**MITSUBISHI HEAVY INDUSTRIES, LTD.**  
16-5, KONAN 2-CHOME, MINATO-KU  
TOKYO, JAPAN

**Subject:** MHI's Responses to US-APWR DCD RAI No.300-2288

**References:** 1) "Request for Additional Information No.300-2288 Revision 1, SRP Section: 06.05.01 – ESF Atmosphere Cleanup Systems, Application Section: Tier 2 DCD 9.4.6" dated April 1, 2009.

Responses to Request for Additional Information No. 300-2288,  
Revision 1

Figure 9.4.6-1 Containment Ventilation System Flow Diagram (2 of 2)

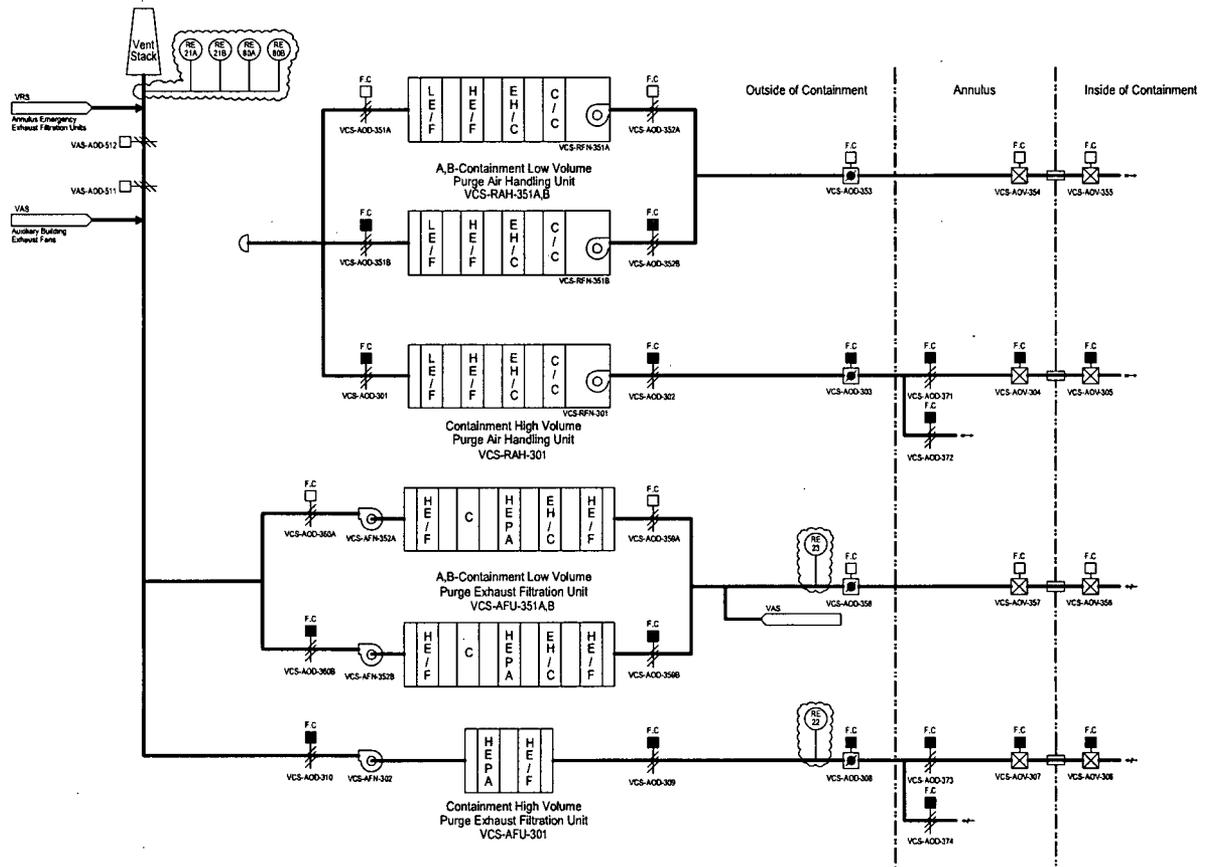
Figure 11.5-1b and Figure 9.4.6-1 collectively fail to allow the staff to determine where the "Containment Low Volume Purge Radiation Gas Monitor" (RMS-RE-23) is located within the Containment Purge Systems' HVAC system ductwork and with respect to the stack ventilation radiation monitors. Figure 9.4.6-1 should display both radiation monitors.

In addition, the relevant radiation monitor wording in DCD sections 9.4.6.5.4.1 and 9.4.6.5.4.2 reads "Alarm high radiation for the containment purge air" leads the reader to believe that only two radiation monitors (RMS-RE-40 & RMS-RE-41 are associated with the HVAC system operation. While these two radiation monitors can cause a CIS and the Containment Purge System shutdown, the "Containment Low Volume Purge Radiation Gas Monitor" (RMS-RE-23) will also alarm with subsequent operator action. From the DCD sections, figures and tables referred to in the applicant's response and reviewed by the staff, is not clear where RMS-RE-23 alarms at (i.e. local alarm or in the MCR)

DCD Figure 9.4.6-1 "Containment Ventilation System Flow Diagram (2 of 2)" will be revised to show the following radiation monitors RMS-RE-22, 23 21A, 21B, 80A and 80B. This revision will clarify the relative position of the radiation monitors with respect to the ventilation system.

1. Revise DCD Figure 9.4.6-1 "Containment Ventilation System Flow Diagram (2 of 2)" per the attached mark-up drawing.
2. Revise DCD Subsection 11.5.2.2.2 "Containment Low Volume Purge Radiation Gas Monitor (RMS-RE-23)" second paragraph as follows:
